# R134 WORST CASE APPROACH FOR SURFACE DAMAGE AND CHEMICAL EXPOSURE TEST.

BMW PROPOSAL AND EXAMPLES.

EA-610, EG-823

# CHAMBER CONFIGURATIONS.

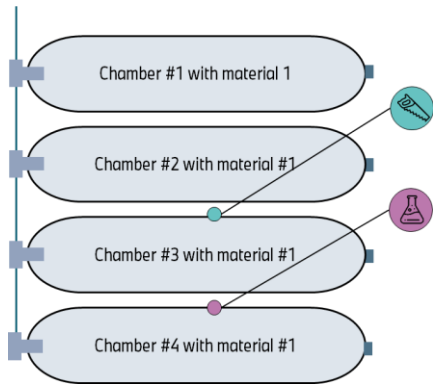
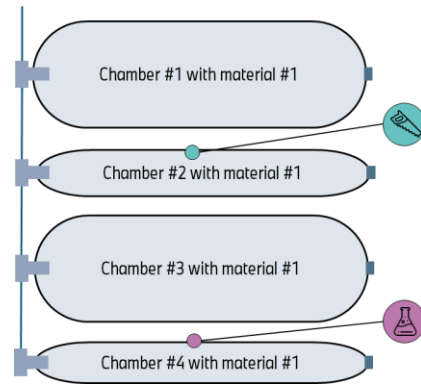
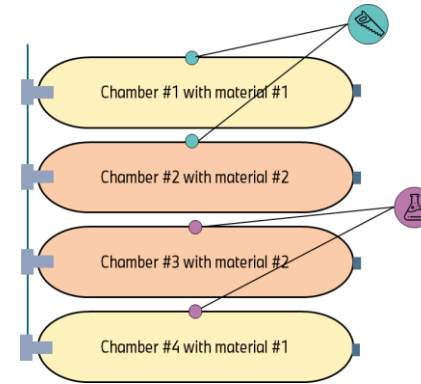
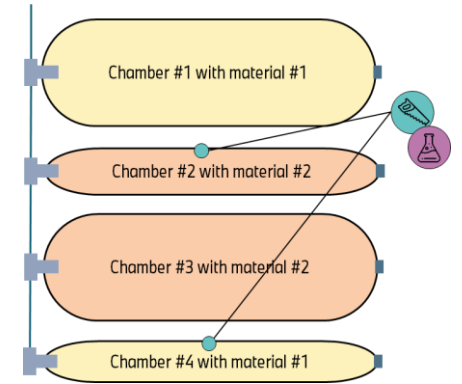
## Premises:

- Container consists of several chambers.
- All chambers are designed for the same burst pressure
- Container attachments are removable and chamber surfaces are accessible.

Chambers have same geometry and same material

Chambers have different geometry and same material

Chambers have same geometry and different material

Chambers have different geometry and different material

Figure 2  
Surface damage flow chart

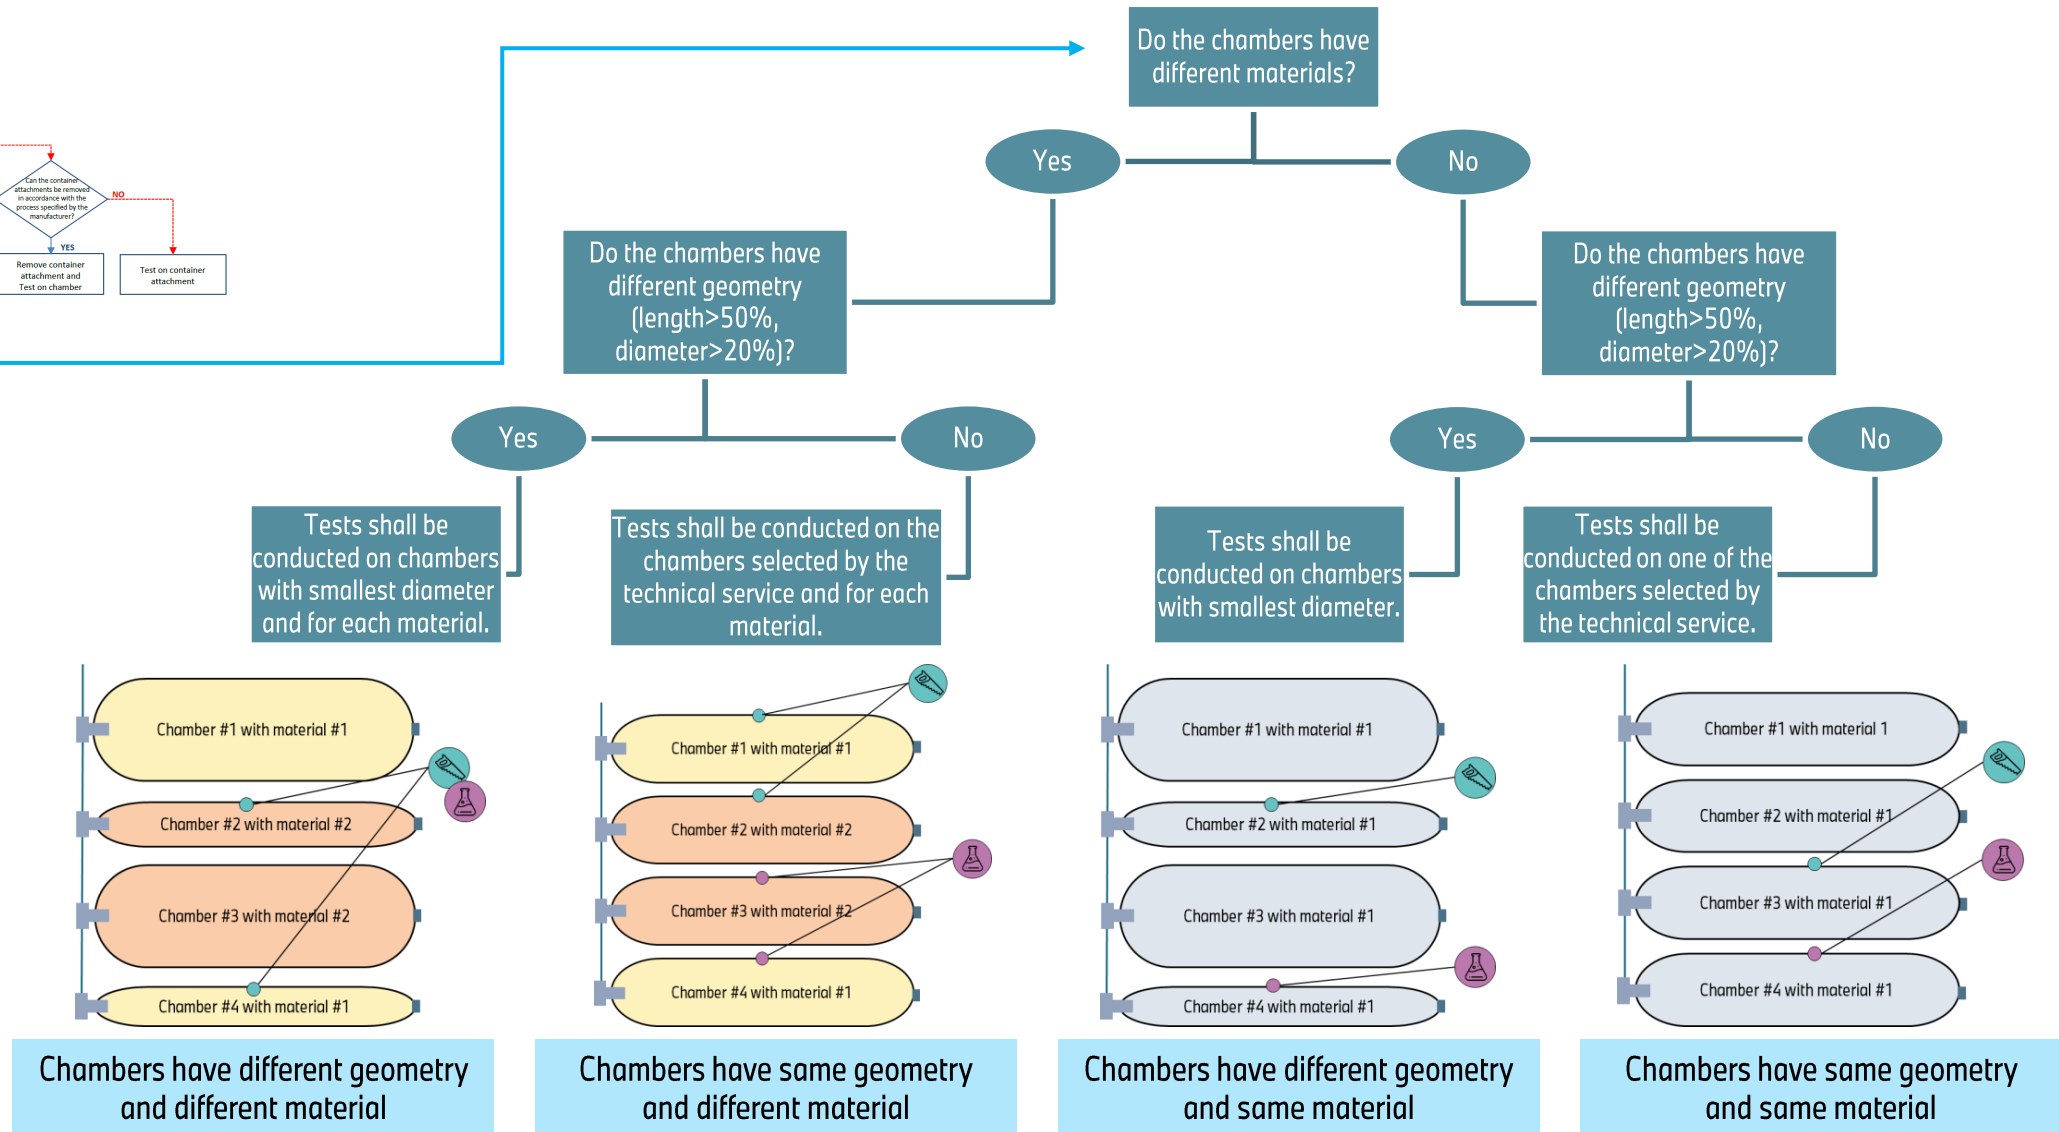
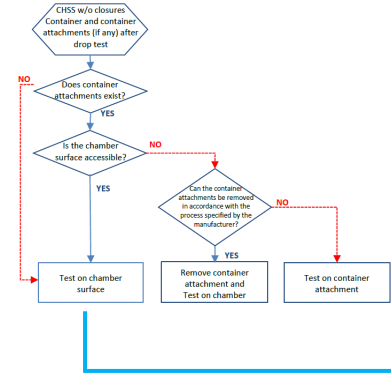
# FLOW CHART AMENDMENT CONSIDERING CHAMBER MATERIAL AND GEOMETRY.

# TYPE OF MATERIAL AND GEOMETRY CHANGES.

Material change	Affecting burst pressure performance	Affecting chemical exposure performance	Comment
Fiber material	Yes	Yes	Test shall be conducted for each material.
Resin material	Yes	Yes	Test shall be conducted for each material.
Fire proof protection	No	Yes	Test shall be conducted for each material.
Glass fiber protection	No	Yes	Test shall be conducted for each material.

Geometry change	Affecting burst pressure performance	Affecting chemical exposure performance	Comment
Length $\leq$ 50%	Not significantly	No	Different geometry, but no significant influence on burst pressure → no additional testing necessary.
Length $>$ 50%	Yes	No	Test shall be conducted for each geometry. See R134 table "change of design".
Diameter $\leq$ 20%	Not significantly	No	Different geometry, but no significant influence on burst pressure → no additional testing necessary.
Diameter $>$ 20%	Yes	No	Test shall be conducted for each geometry. See R134 table "change of design".
